**MACQUARIE POINT MULTIPURPOSE STADIUM PROJECT OF STATE
SIGNIFICANCE (PoSS) - Draft Integrated Assessment Report (IAR)**

**MACQUARIE POINT MULTIPURPOSE STADIUM
PROJECT OF STATE SIGNIFICANCE**

Draft Integrated Assessment Report Submission

Figure 2. Stepped boundary issues between MPDC & TasPorts

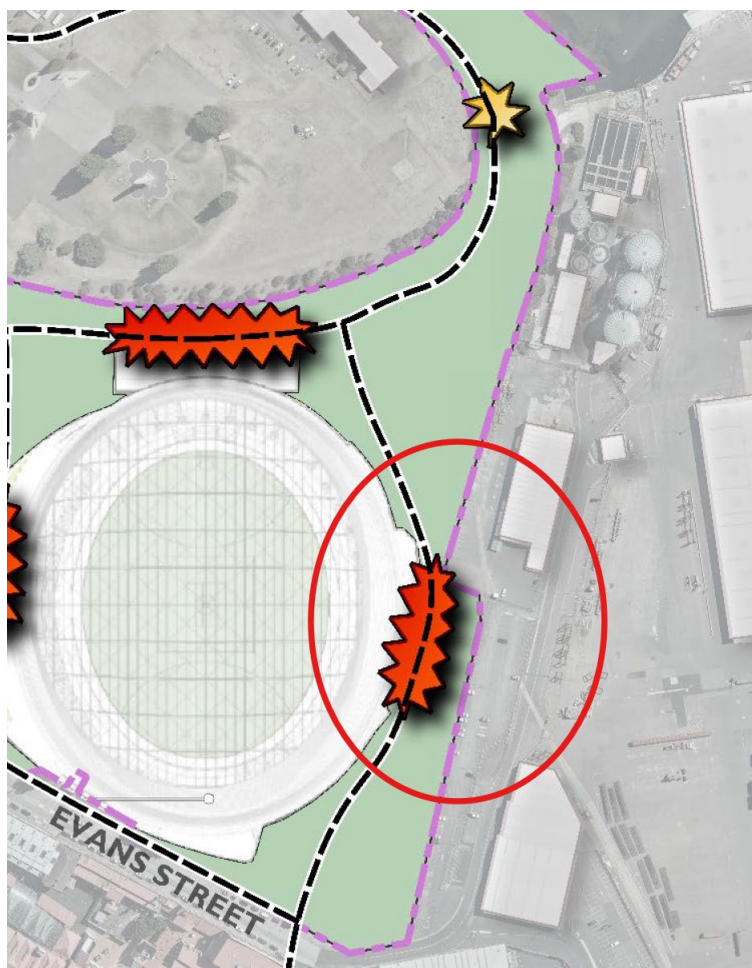
(j) The City agrees with the Panel that in order to improve functionality and safety of the proposed stadium design, additional dedicated space around the stadium building should be sort. The City implores the proponent and TasPorts to consider adjusting the eastern stepped boundary (as shown on Figure 2 below) as a matter of priority to allow for the full realisation of the Complementary Integrated Mixed Use Zone and Antarctic Facilities Zone as originally envisaged which will also go some way to alleviate some of the many pinch points identified around the precinct.
